Amberfield S92 Response

Landscape / Visual Effects / Open Space
Prepared for Weston Lea Ltd

17 August 2018

DRAFT ONLY

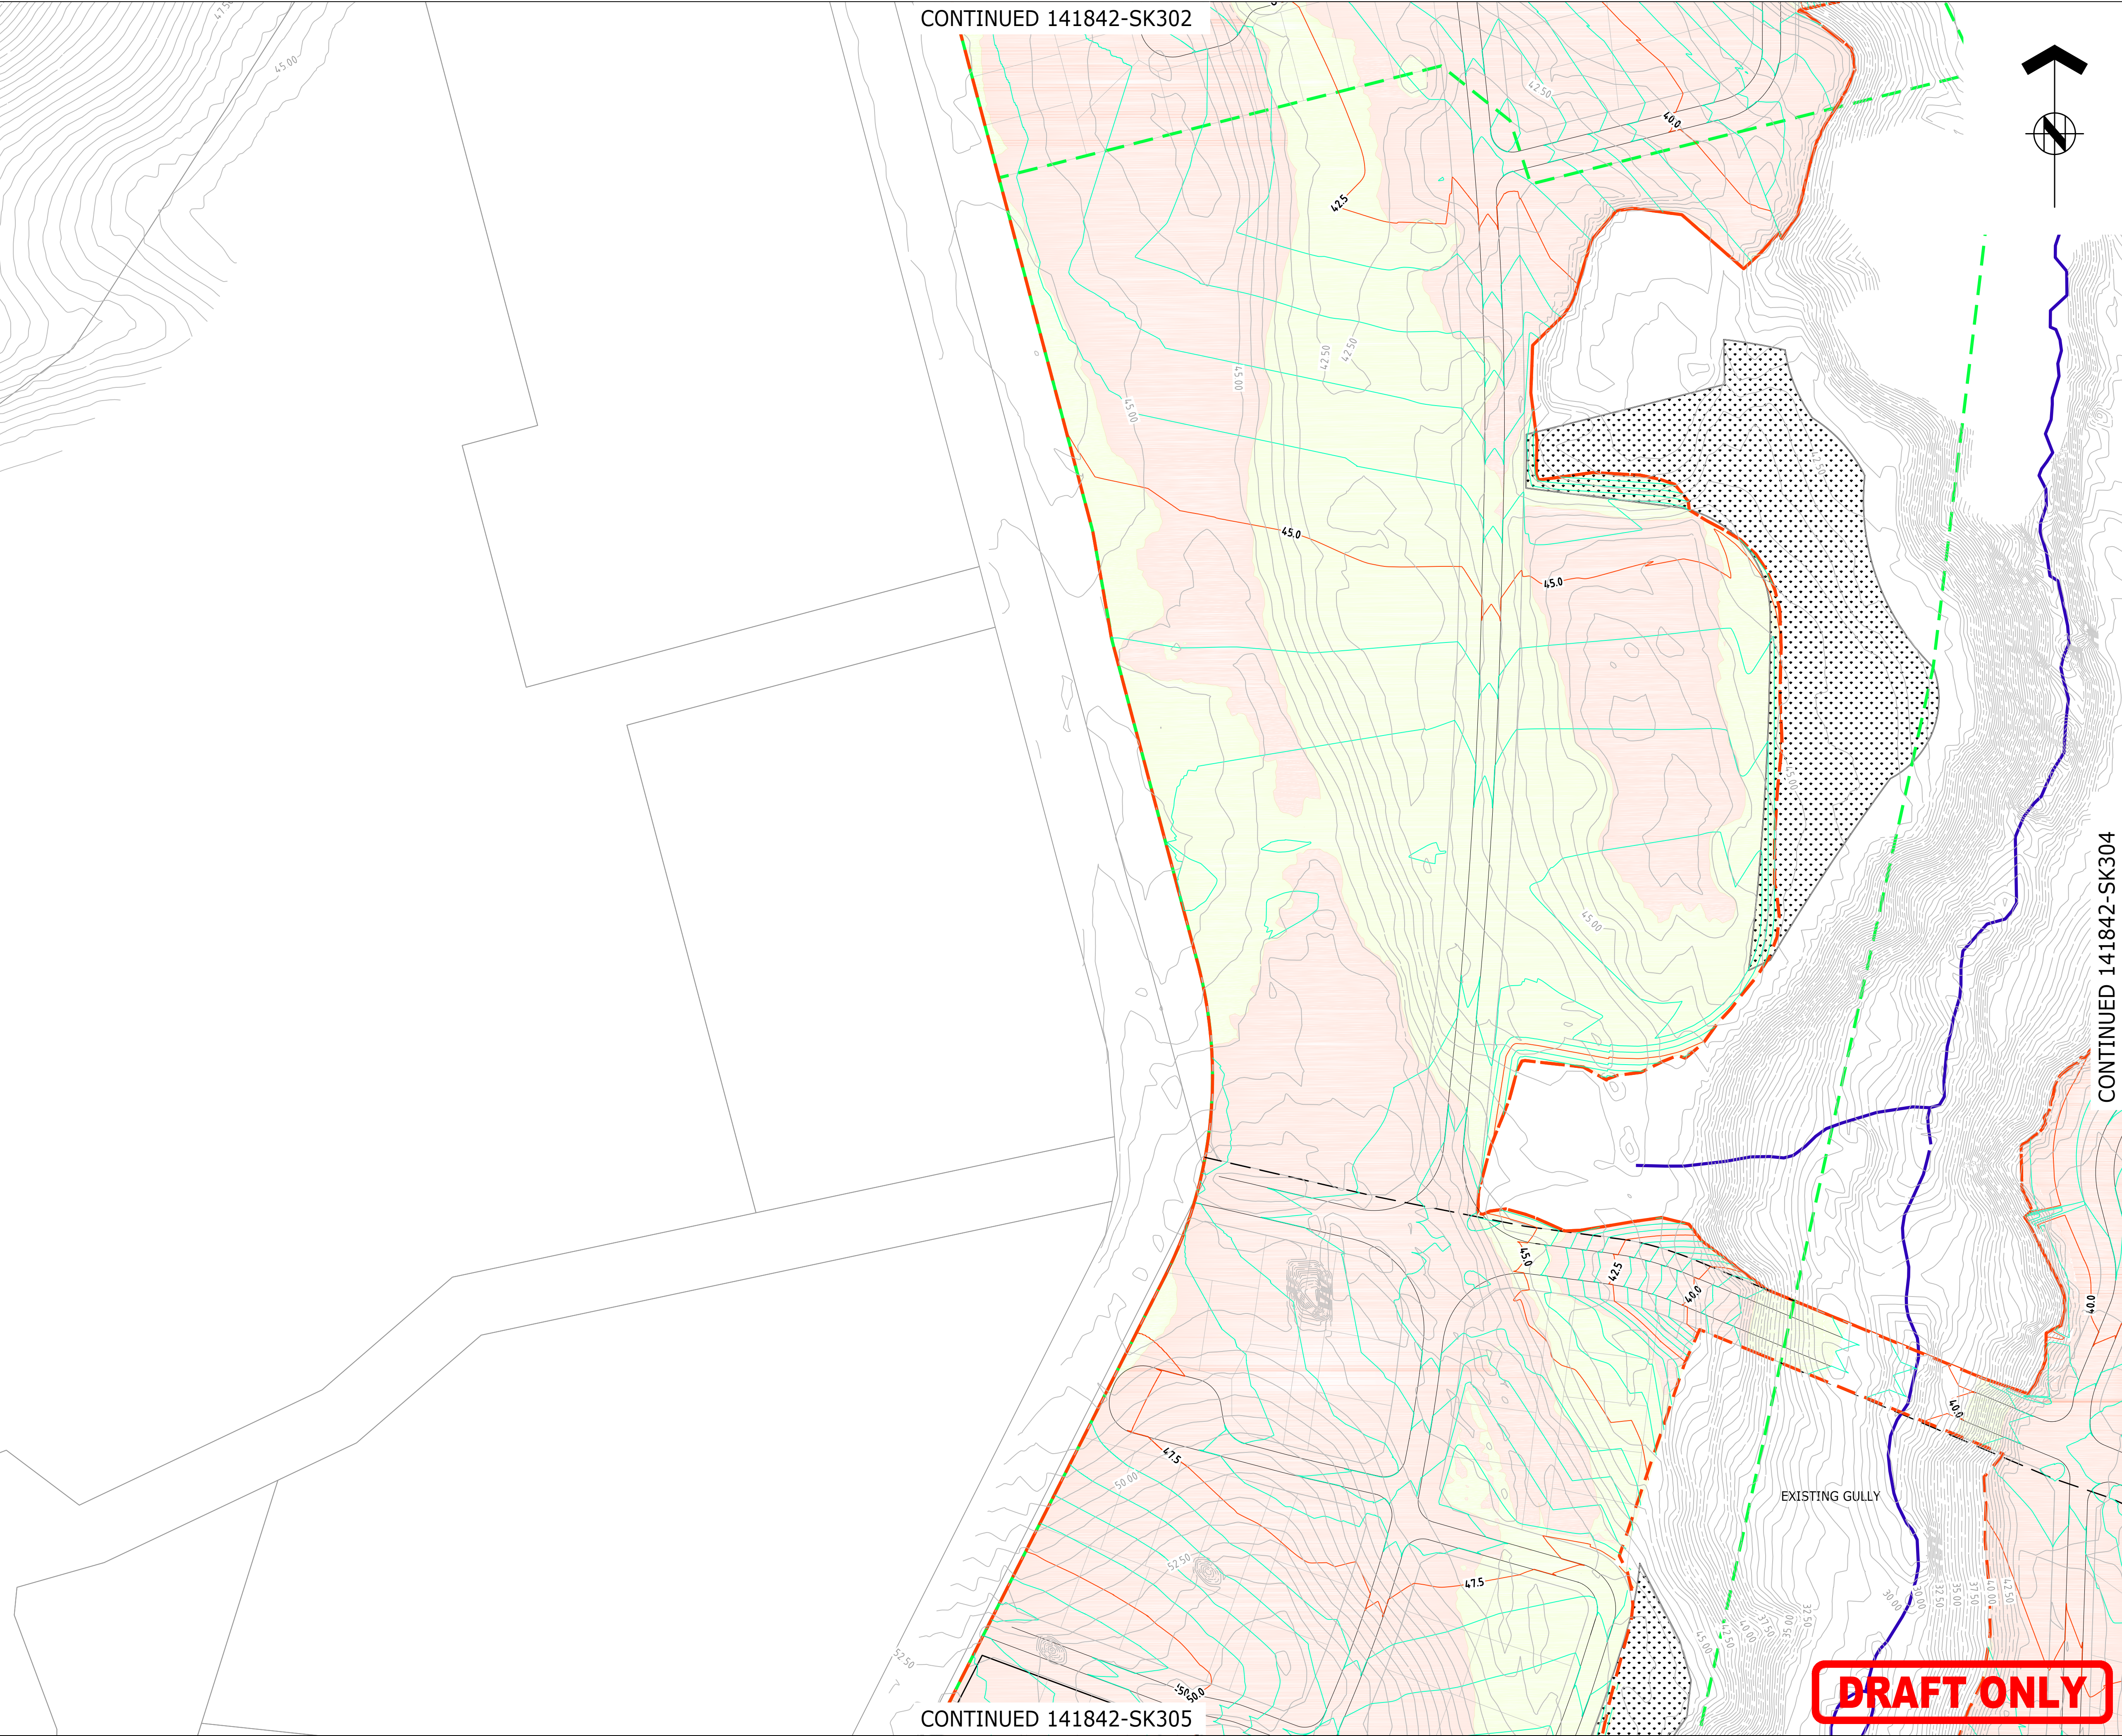
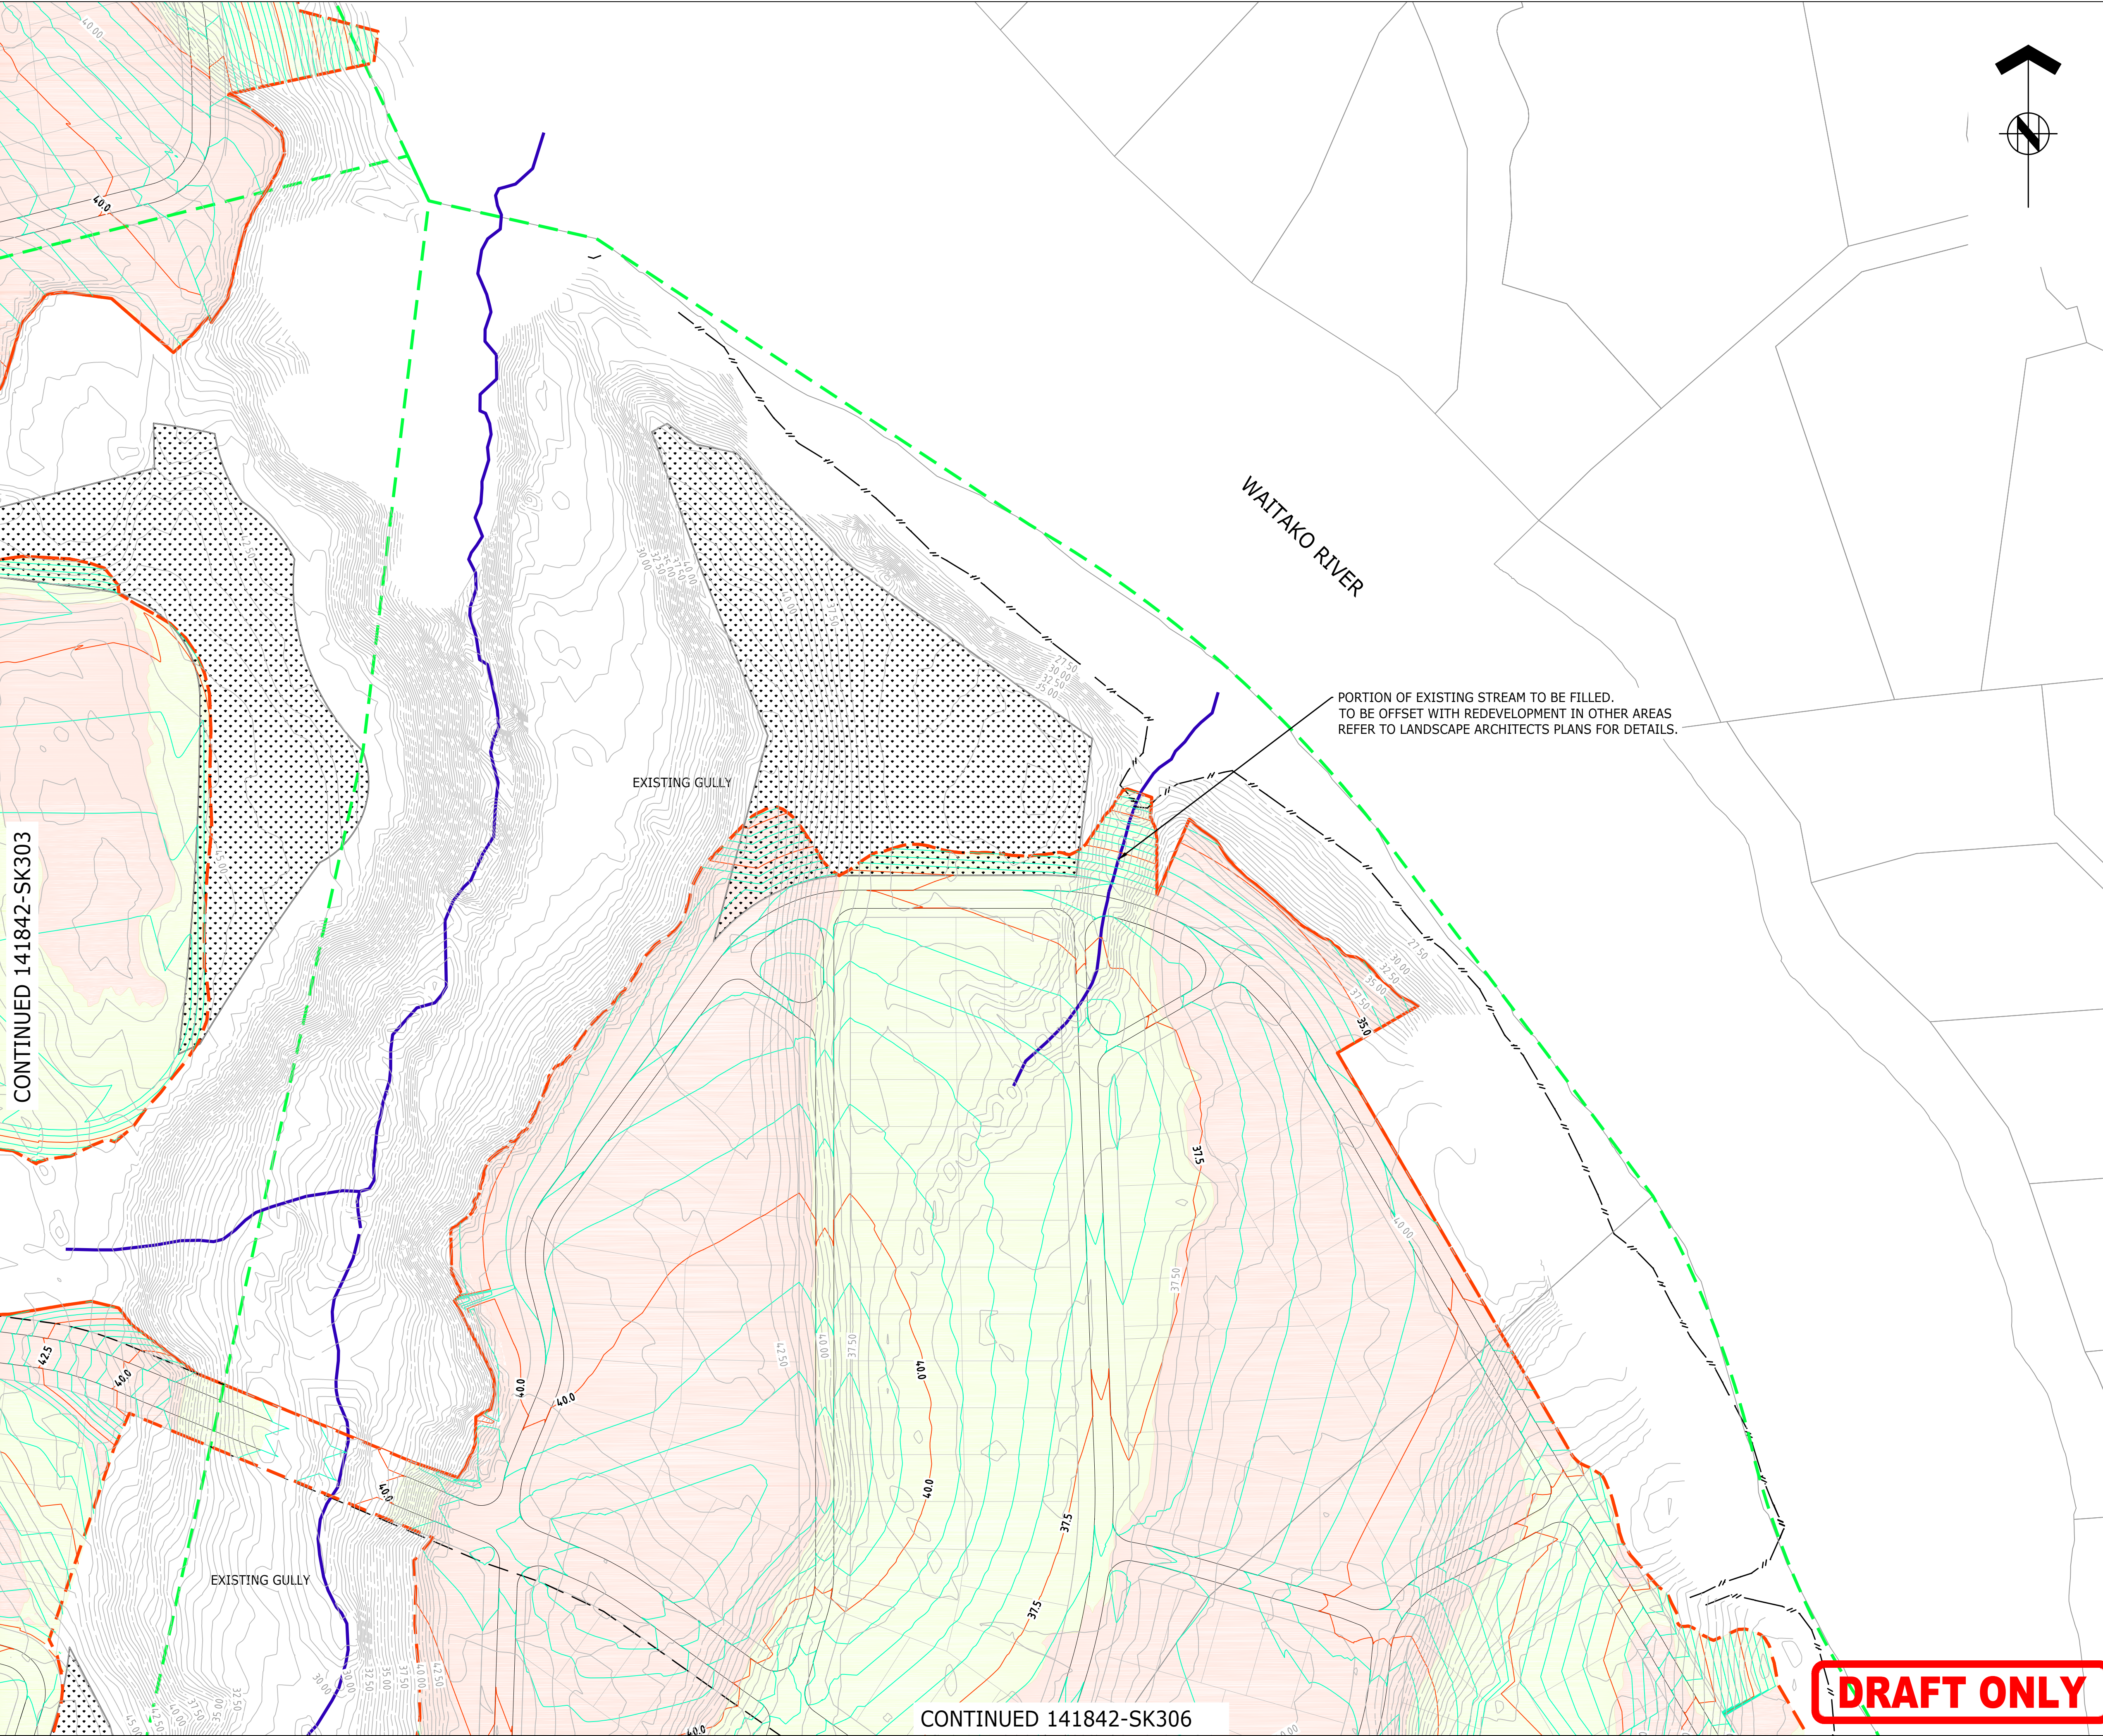
The additional H&G Cut and Fill drawings; 141842-SK301 to SK306, now clearly showing the existing and proposed contours, show the general smoothing off of the landform consistent with earthworks to enable urban development, the grading to achieve street gradients / connections and the proposed terracing of the site. As already noted the greatest level of modification is to 'The Island' landform which will remain strongly defined by the gully system to the west and river corridor to the east retaining the separate identity of this part of the overall site topography.
